**PLANNED UNIT DEVELOPMENT
& SUBDIVISION STAFF REPORT****August 7, 2014**

<u>DEVELOPMENT NAME</u>	Twister 303 Subdivision
<u>SUBDIVISION NAME</u>	Twister 303 Subdivision
<u>LOCATION</u>	(Southeast corner of University Boulevard and Overlook Road).
<u>CITY COUNCIL DISTRICT</u>	District 7
<u>AREA OF PROPERTY</u>	5 Lots / 14.3 ± acres (Subdivision) 5 Lots / 14.3 ± acres (Planned Unit Development)
<u>CONTEMPLATED USE</u>	Planned Unit Development approval to allow shared access and parking across multiple lots and multiple buildings on a single building site.
<u>TIME SCHEDULE FOR DEVELOPMENT</u>	None given.

SITE PLAN

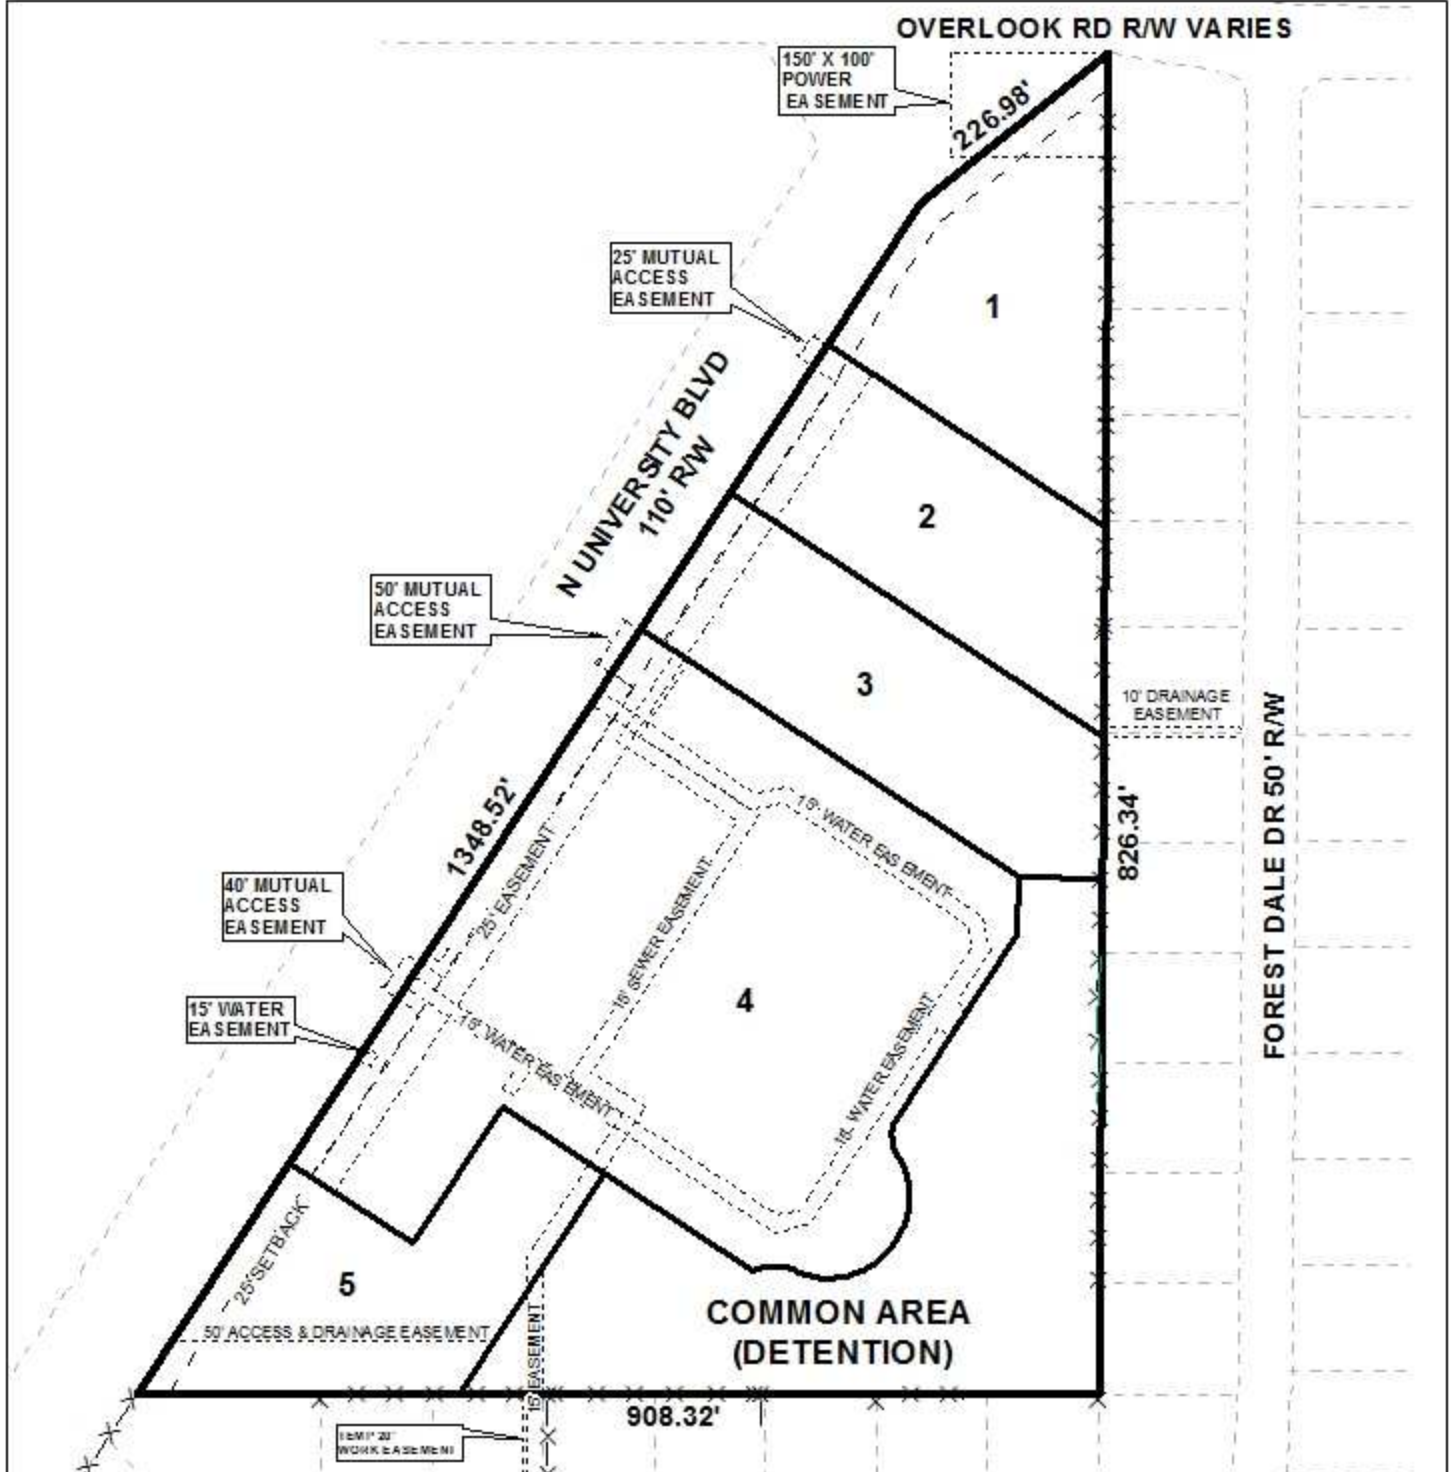
It should be noted there is a discrepancy between the subdivision plat and the PUD site plan. The preliminary plat depicts a 25' minimum building setback line whereas the site plan depicts a 50' minimum building setback line. Also, the 50' minimum building setback line as indicated on the site plan measures to be approximately 20'. A revised site plan should be submitted to depict a minimum 25' building setback line and address the inconsistency between the preliminary plat and the site plan.

The applicant has submitted a site plan illustrating the placement of the parking spaces, proposed buildings, dumpsters, and existing trees; however no tree and landscaping calculations have been provided. The site plan should be revised to depict the lot sizes in square feet and acres, provide the frontage and total landscaping calculations, and the total number of frontage trees and perimeter trees. A minimum of 128 trees, to include: 44 frontage trees, 65 perimeter trees, and 19 parking trees will be required. A revised site plan will be required prior to issuance of any permits for the site, and prior to the signing of the Final Plat.

The site plan depicts 60,309 ± square feet of building footprint and a total of 365 parking spaces for the entire site. The site plan separates the parking spaces for each proposed lot; it appears that lots 1-3 and 5 will have sufficient parking for uses requiring a 1/100 square foot parking ratio, while lot 4 will have sufficient parking for uses requiring a 1/300 square foot ratio.

The proposed Lot 4 is a retail grocery store with a drive-thru pharmacy and ancillary gas station. Section 64-4.F.2 of the Zoning Ordinance addresses design standards for drive-thru business. All queuing spaces must be 9 feet wide by 20 feet long. Each drive-thru lane must provide a minimum of 3 queuing spaces from the street right-of-way to the service window. The site plan illustrates the pharmacy service window but does not illustrate queuing spaces. Also, it appears that drive throughs may be proposed for each of the other lots, however, there are no labels to confirm this. A revised site plan illustrating the location of the service window and queuing spaces will be required.

The site plan fails to illustrate the location of proposed freestanding signage. While each lot will be a separate legal lot of record it is not known if each lot will be for a single or multi-tenant building. If the applicants wish to deviate from the standard sign allowance, sign information must be included with the site plan requesting the total number of signs for each business and illustrating the locations of the signs. All proposed signage must be depicted on the site plan. The applicant(s) have stated that "the developer shall determine at a later time what the specific tenant and use of each of the outparcels will be". The applicant(s) should be aware that the submission of a PUD application to amend the previous PUD will be required for any changes made to the site plan once approved by the Planning Commission.

Dumpsters are depicted on the site plan and do appear to be enclosed on all three sides. However, there is no indication that the dumpster will be connected to sanitary sewer. Site plans submitted for permitting should be revised to indicate if the dumpsters will be connected to sanitary sewer. It should also be noted, when submitting for a building permit, detailed plans

The site is adjacent to residentially zoned property and thus requires a protective buffer as referenced in Section 64-4.D.1 of the Zoning Ordinance. The site plan depicts a 10' building setback line that is located along the entire site, as well as a 6' wooden privacy fence that is along most of the perimeter where the site abuts residential properties.

- 1) revise the site plan to depict the same lot sizes in square feet and acres to coincide with the lot sizes on the preliminary plat;
- 2) revise the site plan to accurately depict the 25' minimum building setback line to coincide with the preliminary plat;

- 8) revise the site plan to provide the landscaping frontage and total landscaping calculations;
- 9) revise the site plan to depict frontage trees and perimeter trees;

- 10) revise the site plan to illustrate the location of the service window and queuing spaces for all proposed or anticipated drive-throughs;
- 11) retention of dumpsters on the site plan;

- 12) placement of a note on the site plan stating dumpsters will be enclosed on all three sides and connected to sanitary sewer;
- 13) revise the site plan to depict the location of wall and freestanding signage for the site;
